Environmental
Protection Agency

October 11, 2011

Re: Bloom Carroll Middle School / Fairfield County

This letter is written in follow-up to a construction storm water inspection that I conducted at the Bloom Carroll Middle School project located along Beaver Street. The inspection was conducted on September 30, 2011. The reason of the inspection was a follow-up to a previous storm water inspection. During the inspection, the following items were noted:

Bloomington, MS
Hudson road
Cahoon Creek Watershed
September 30, 2011
Photo by Greg Sanders

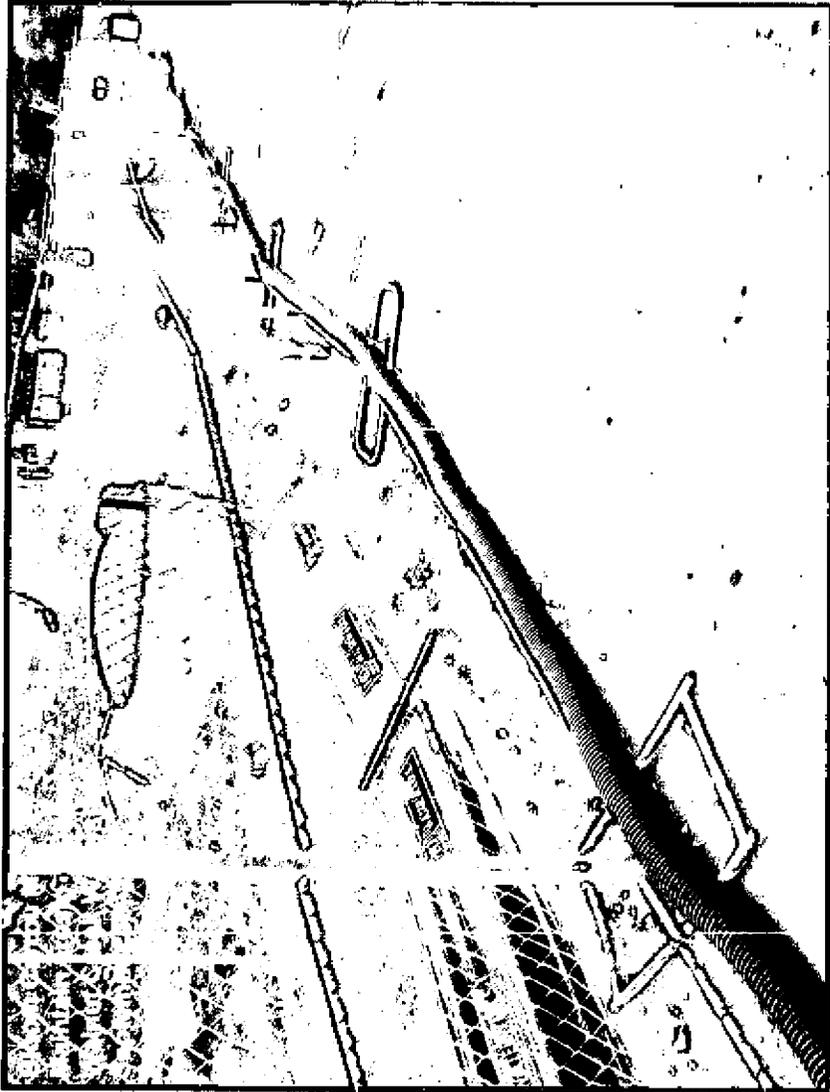
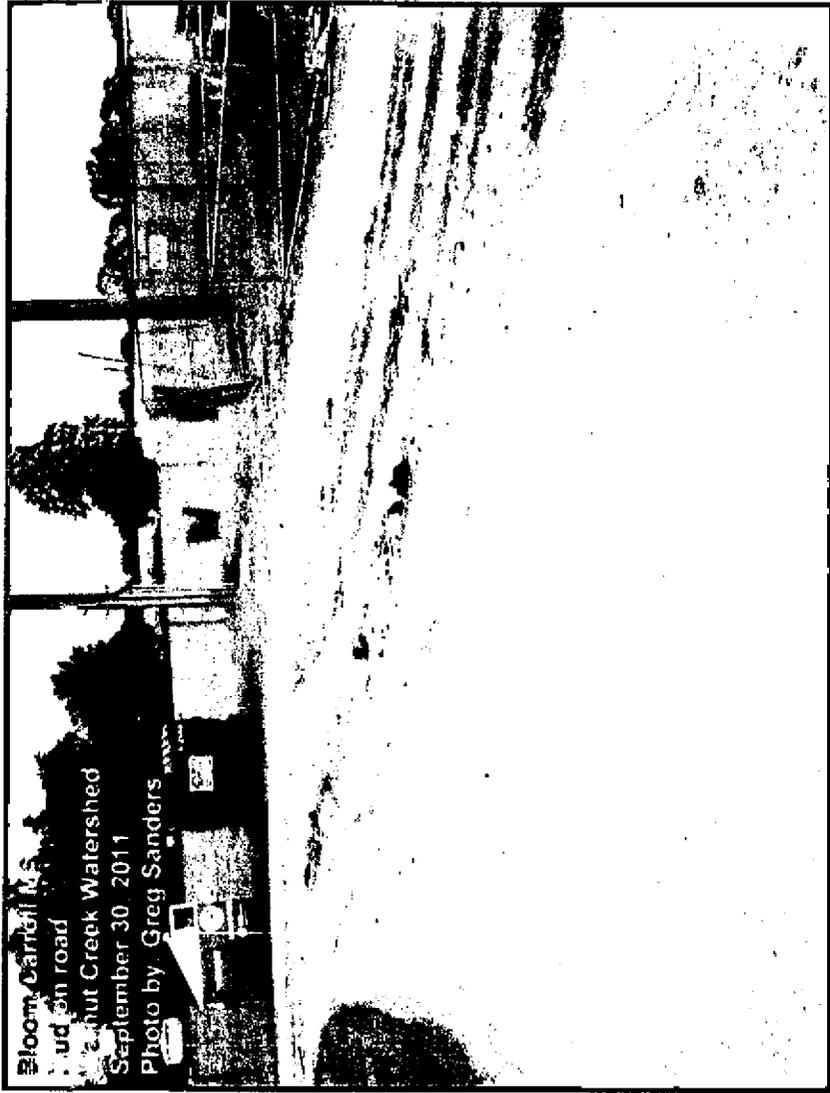
Please install and maintain erosion controls around the construction site. Please see attached pictures.

Mud is being tracked on to the road in the front and to the side of the school. Please install erosion controls to prevent mud from being tracked off-site. Please see attached pictures.
